MIL ON With DTC P060694

YEAR(S)	MODEL(S)	ADDITIONAL INFORMATION
2021 - 2022	RAV4 Prime

Some 2021 – 2022 model year RAV4 Prime vehicles may exhibit a MIL ON condition with Diagnostic Trouble Code (DTC) P060694 (SAE code P0606) (Control Module Processor Unexpected Operation) present. The Hybrid Vehicle Control Computer logic has been modified to reduce the possibility of this condition. Follow the Repair Procedure in this bulletin to address this condition.

Figure 1. Location of Authorized Modifications Label on 2021 – 2022 RAV4 Prime

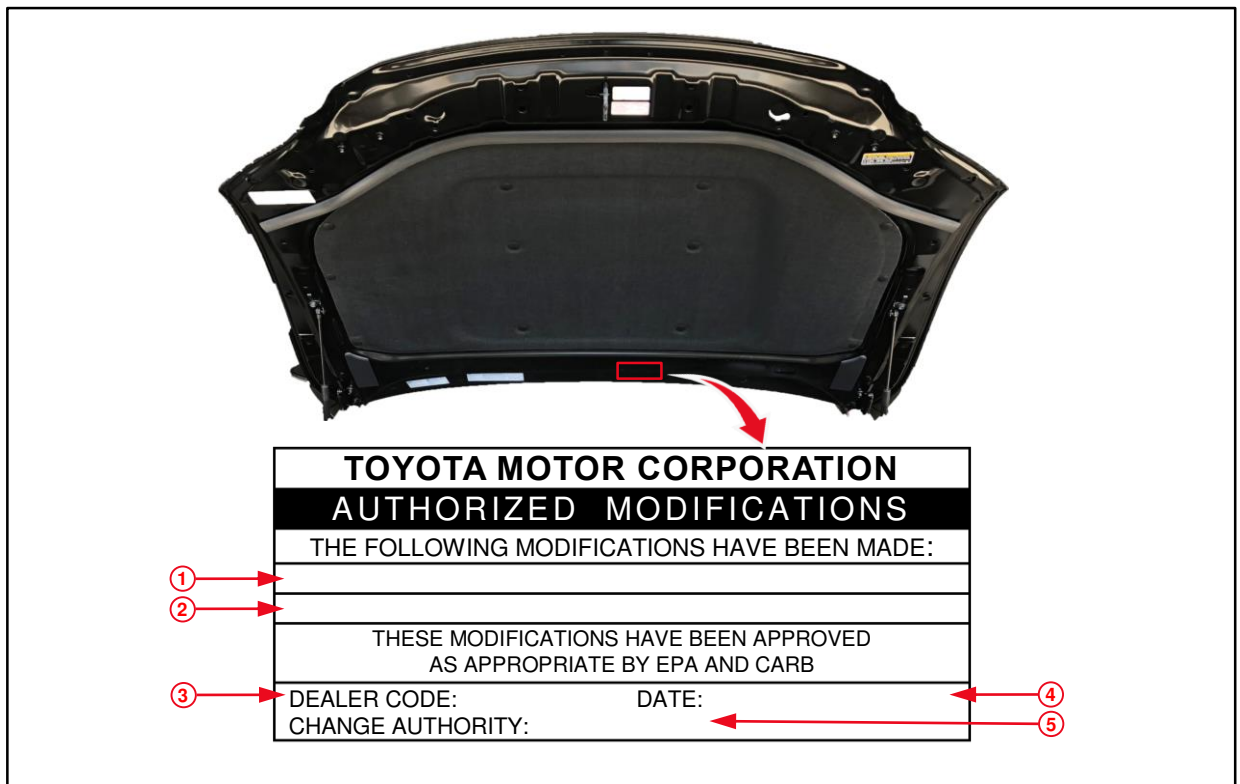
2. Check for the Authorized Modifications Label affixed to the vehicle in the location shown below. Confirm if the Hybrid Control Module calibration has been updated.

Is the calibration ID listed the latest Hybrid Vehicle Control Computer calibration?

4. Prepare and install the Authorized Modifications Label.
 - A. Using a permanent marker, enter the following information on the label:
 - Hybrid Control Module part number [Refer to the **Parts Information** section for the **NEW PART NUMBER**]
 - Calibration ID(s) [Refer to the **Calibration Information** section for the **NEW CALIBRATION ID**]
 - Dealer Code
 - Repair Date
 - Change Authority [This bulletin number]
 - B. Affix the Authorized Modifications Label to the vehicle at the location shown in Figure 1. The Authorized Modifications Label is available through the MDC, P/N 00451-00001-LBL.
5. Test-drive the vehicle to confirm normal vehicle operation and the condition is no longer present.
